From: WILLIFORD Dennis (AREVA) [Dennis.Williford@areva.com]
Sent: Friday, March 01, 2013 3:24 PM
To: Snyder, Amy
Cc: Hearn, Peter; DELANO Karen (AREVA); LEIGHLITER John (AREVA); ROMINE Judy (AREVA); RYAN Tom (AREVA); WILLS Tiffany (AREVA); KOWALSKI David (AREVA)
Subject: Response to U.S. EPR Design Certification Application RAI No.406, FSAR Ch. 9, Supplement 15
Attachments: RAI 406 Supplement 15 Response US EPR DC.pdf
Importance: High

Subject: Response to U.S. EPR Design Certification Application RAI No.406, FSAR Ch. 9,
Supplement 15
Sent Date: 3/1/2013 3:24:13 PM
Received Date: 3/1/2013 3:24:55 PM
From: WILLIFORD Dennis (AREVA)

Question 09.02.02-114:

Figure 9.2.2-2—Component Cooling Water System Common Loop 1
Sheet 7 of 7

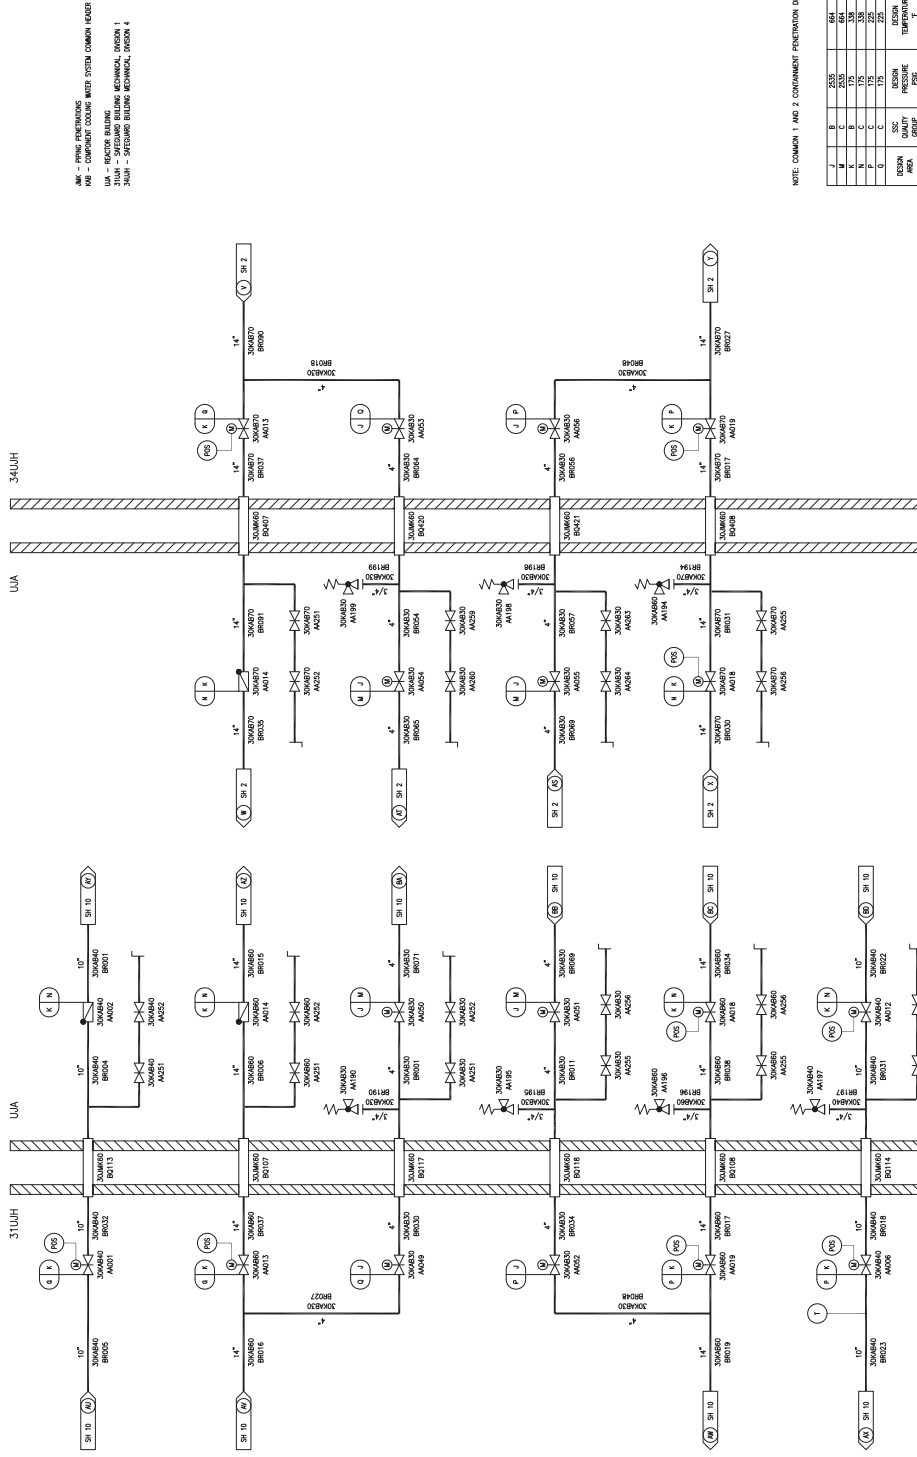
In follow-up RAI 9.2.2-69 the staff concluded that the response and markup of FSAR Tier 2 Section 9.2.2 provided by the applicant for RAI 9.2.2-20 did not specifically demonstrate satisfying the guidance of SRP 9.2.2 Section II 4.G ii. In follow-up RAI 9.2.2-69 the staff noted examples of information needed in the FSAR markup to more completely identify the CCWS thermal barrier cooling design including; (1) Specifically state the CCWS associated with the RCPs can withstand a single, active failure or a moderate-energy crack as defined in Branch Technical Position ASB 3-1, (2) Also credit Seismic Category I, Quality Group C, and ASME Section III Class 3 requirements and (3) to identify that future RCP seal SBO testing would be performed.

- a. In regard to the discussion in the response about mid position failure of a thermal barrier containment isolation valve (CIV) upon attempting transfer of thermal barrier cooling to the other common header:

3. Describe in the FSAR if the plant design basis requires CCWS thermal barrier cooling to be functional in post accident conditions (besides during all plant operating modes when the RCPs are running).

4. The applicant's response stated that failure of a CCWS CIV to fully close does not place the plant in a four hour TS action statement to close the other CIV in that flowpath but TS 3.6.3 Containment Isolation does apply. The applicant should provide the basis for these conclusions and explain the aspect of TS 3.6.3 that does apply including the applicable LCO duration.

5. Describe in the FSAR if the RCP standstill seal (discussed in the original response) is credited as a safety-related design basis accident mitigation feature or is it intended only for conditions that are beyond the normal design basis.

- b. Provide an explanation in the RAI response that demonstrates that the guidance of SRP 9.2.2, Section II 4.G is satisfied by testing that the RCPs can withstand a complete loss of cooling water for 20 minutes without operator action or state that in lieu of testing the CCWS meets Section ii.4.G, item ii. This was not addressed as requested by RAI 9.2.2-69.

A reduction or loss of CCWS flow to any of the RCP thermal barriers is recognized in the control room by individual flow indication devices in the return piping from each thermal barrier (refer to U.S. EPR FSAR Tier 2, Figure 9.2.2-2, sheets 3 and 4 and Figure 9.2.2-3, sheets 3 and 4). A reduction or loss of CVCS seal injection flow to the RCPs is recognized in the control room by a totaling flow indication device outside containment, and individual flow indication devices for each RCP seal (refer to U.S. EPR FSAR Tier 2, Figure 9.3.4-1).

Either the common 1.b or 2.b headers can provide cooling to the RCP thermal barriers. To maintain strict train separation of the redundant CCWS division supplying either common header to confirm that a fault affects no more than one train, the CIVs (KAB30 AA049/050/051/052/053/054/055/056) are interlocked. One of the two common 1.b supply valves (KAB30 AA049/050) and one of the two common 1.b return valves (KAB30 AA051/052) must be closed prior to opening the CIVs from the common 2.b header (KAB30 AA053/054/055/056), and vice versa. The functional logic is shown on Figure 7.6-2.

To maintain cooling to the RCP thermal barriers an interlock function is required to open the CIVs on the common header removed from service (common 1.b or 2.b) when a CIV on the common header in service (common 2.b or 1b, respectively) is closed. The functional logic is shown on Figure 7.6-12.

All Indicated Changes are in Response to RAI 406 09.02.02-114
